Route Access Condition Notice

19-0003

Distributed To:	ARTC Website
Distribution Date:	15/02/19
Requested By:	ARTC
Subject:	Re-instating of Maryborough Line for VLine.
Effective Period:	Until Published
Amendment Type:	Permanent (to be added to RAS)

This RACN replaces 190001 and details the V-Line project to form a new connection to the ARTC Standard Gauge Laverton-Wolseley line off the Maryborough Line near Ararat.

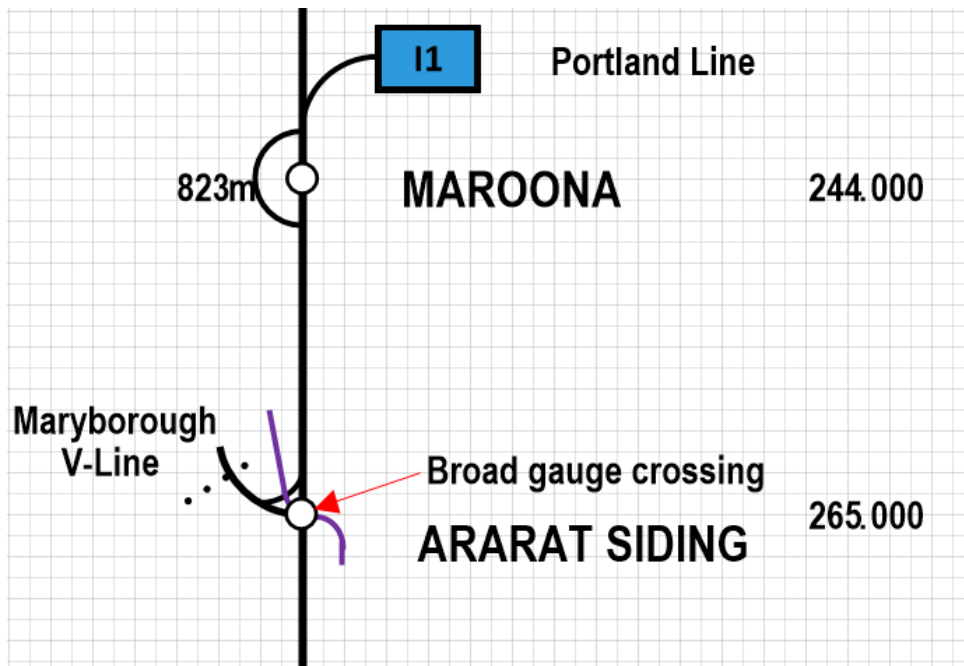
D2 changes below:

MAROONA	243.810 KM	244.000 KM	90
	NOTE: 243 KM TO 244 KM IS A LONG KILOMETRE 1290M		
	262.750 KM	263.780 KM	100
	263.780 KM	264.790 KM	60
	264.790 KM	265.920 KM	75

LAVERTON – WOLSELEY		
LOCATION	MAXIMUM SPEED	
	WHEN RUNNING FROM LINES DIVERGING FROM THE STRAIGHT TRACK (KM/H)	WHEN RUNNING ON THE STRAIGHT TRACK (KM/H)
OVER FACING POINTS HELD BY HAND	15	15
BETWEEN SOUTHERN CROSS AND WOLSELEY	40	LINE SPEED FOR TYPE OF TRAIN
ARARAT to MARYBOROUGH Line	30	AS PER POSTED PERMENANT SPEED
